Re-submittal Form

Project Name: 55th Street T & T Bar - Case Number – VSP2024-00027

55TH STREET BAR

SITE DEVELOPMENT PLAN

SITE PLAN

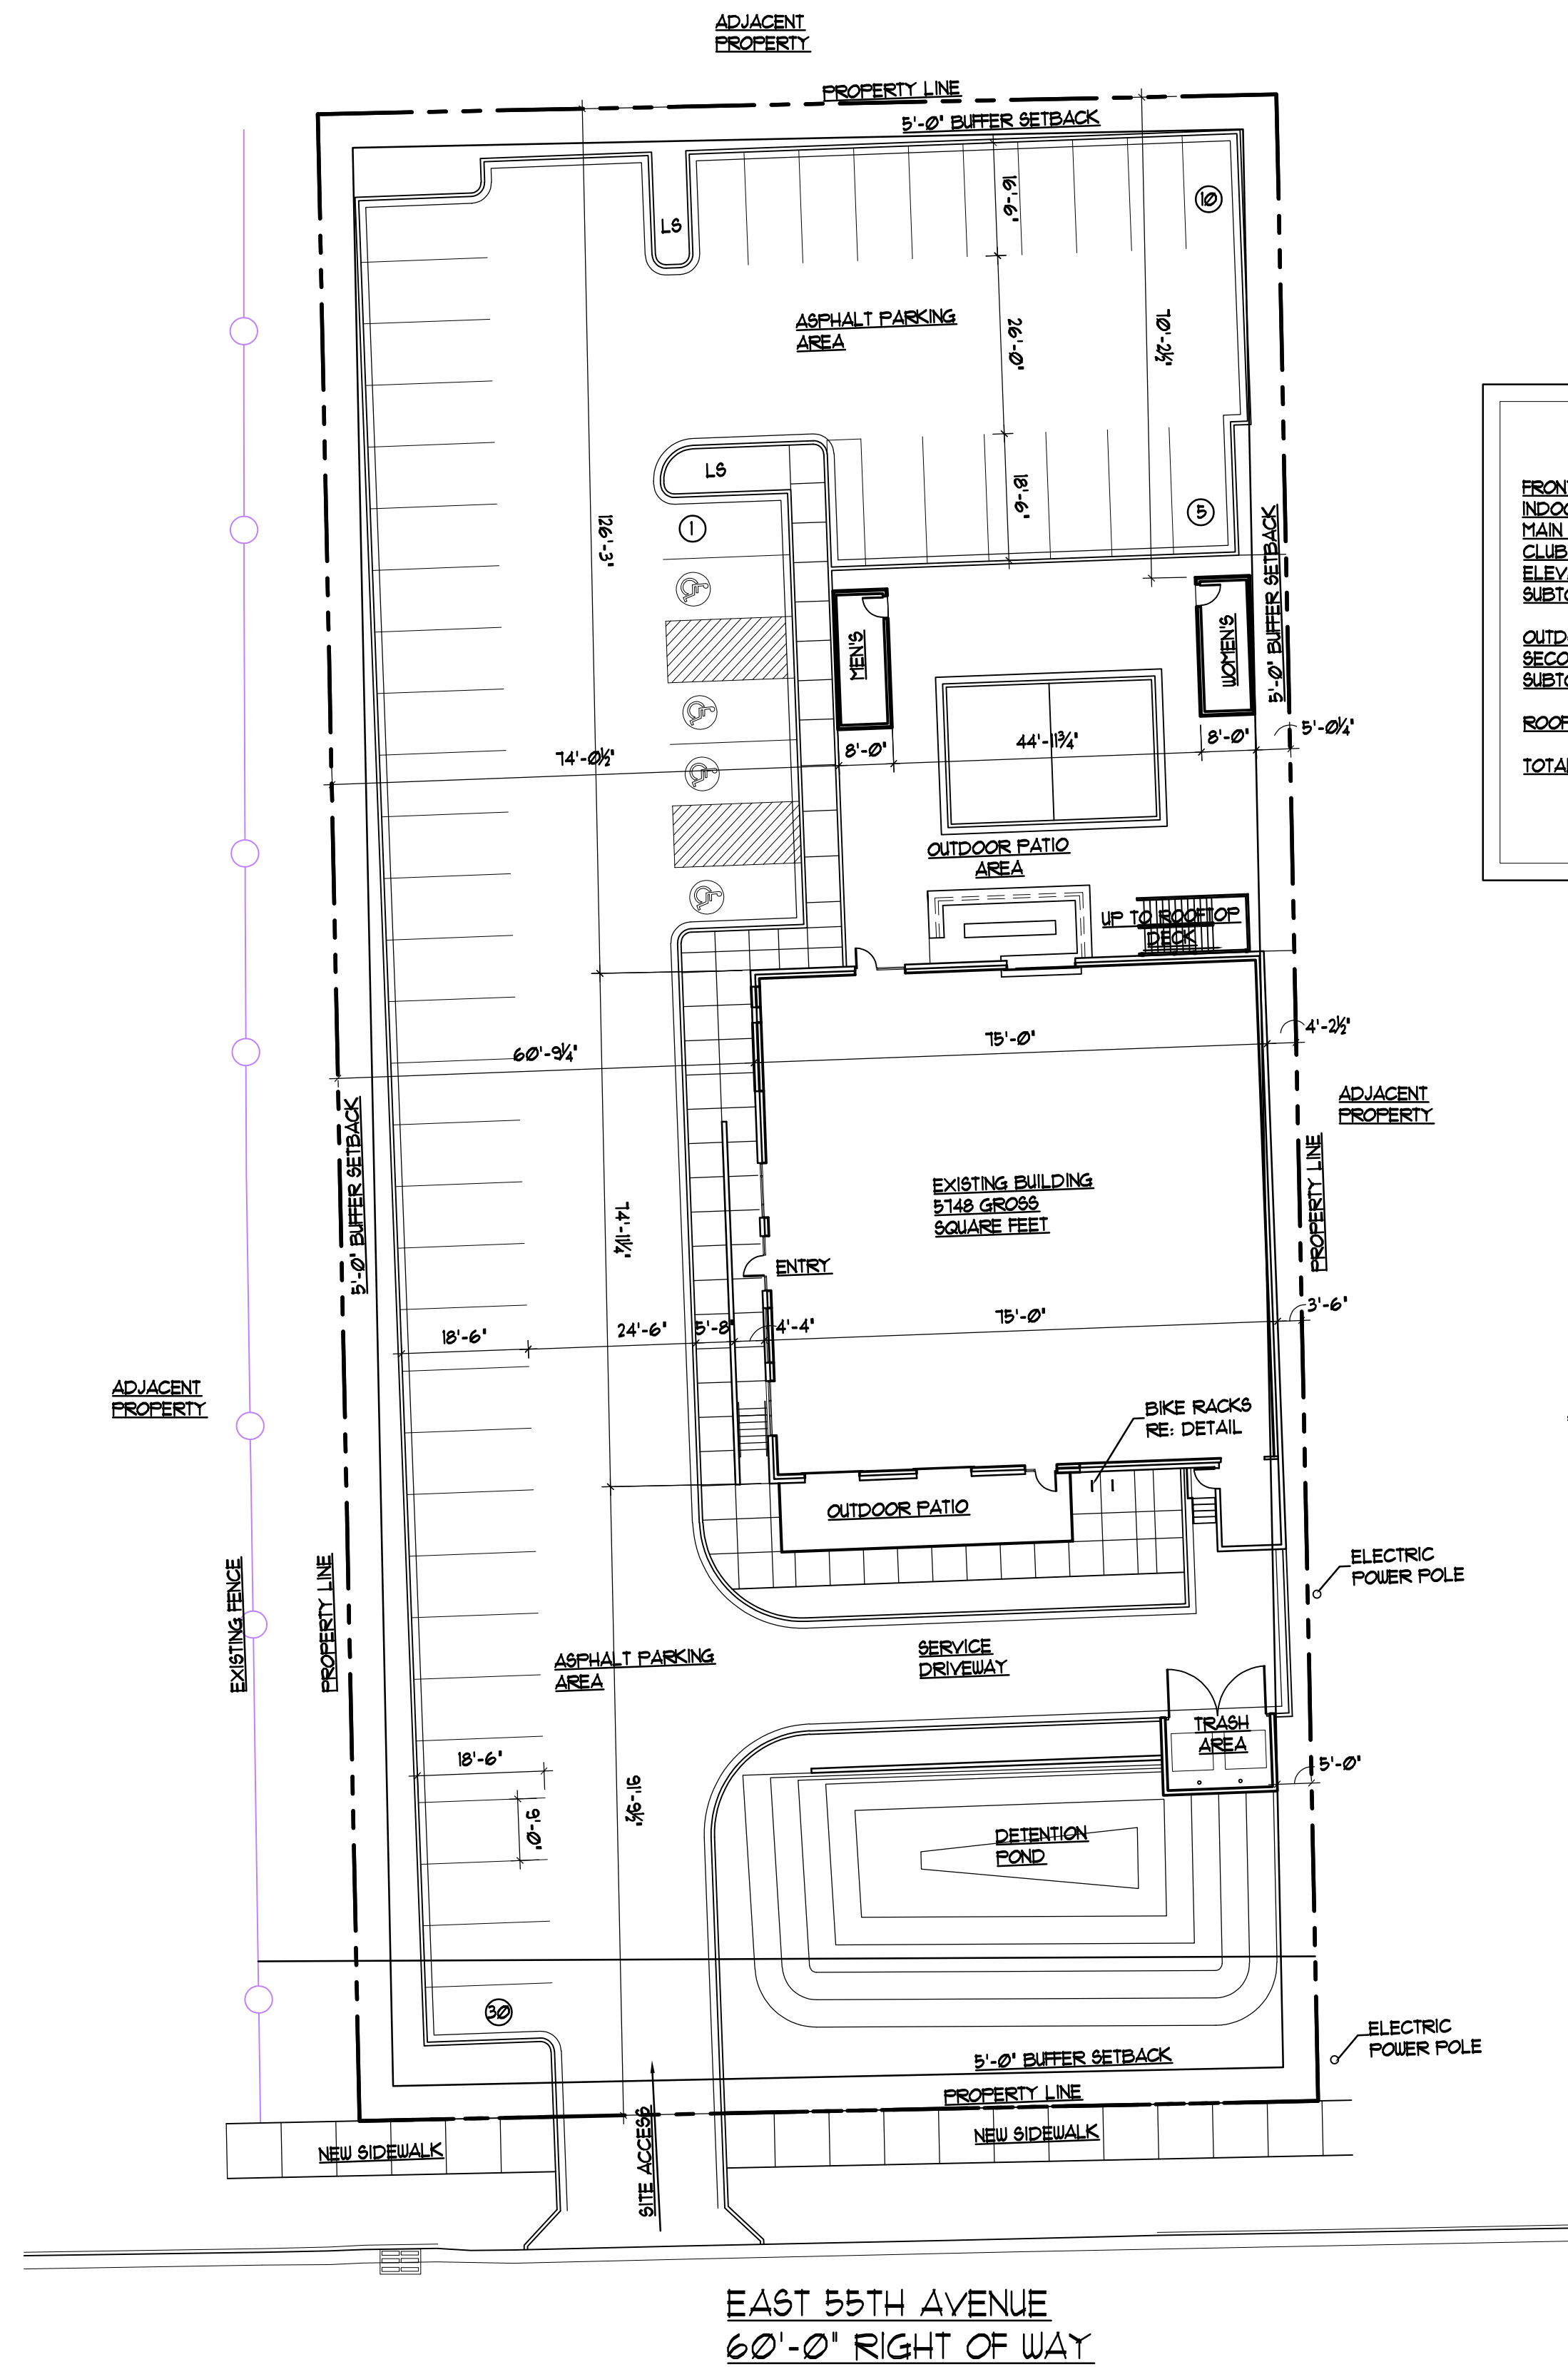
PLN3: The request says 81 spaces, but the totals amount to 86 spaces. Which is it? If the site plan needs to change, then you'll need to resubmit with an updated site plan with parking table. If it's the request (81) that can be easy, just request that upon resubmittal. [As discussed at our meeting, all of the plans indicate 86 spaces are required. We do not see 81 spaces on any of the plans, forms, or letters. No change to the plans are required as 86 is the correct number.](#)

PLN4: Moreover, the parking chart table says "Elevated Seating Area" and then attaches "16 Occupants" to it. When it says "occupants" do you mean "seats"? Based on "Elevated Seating Area" I would presume seats, but this needs to be clearer throughout. [We have revised our chart to indicate seats in lieu of occupants for clarity as requested.](#)
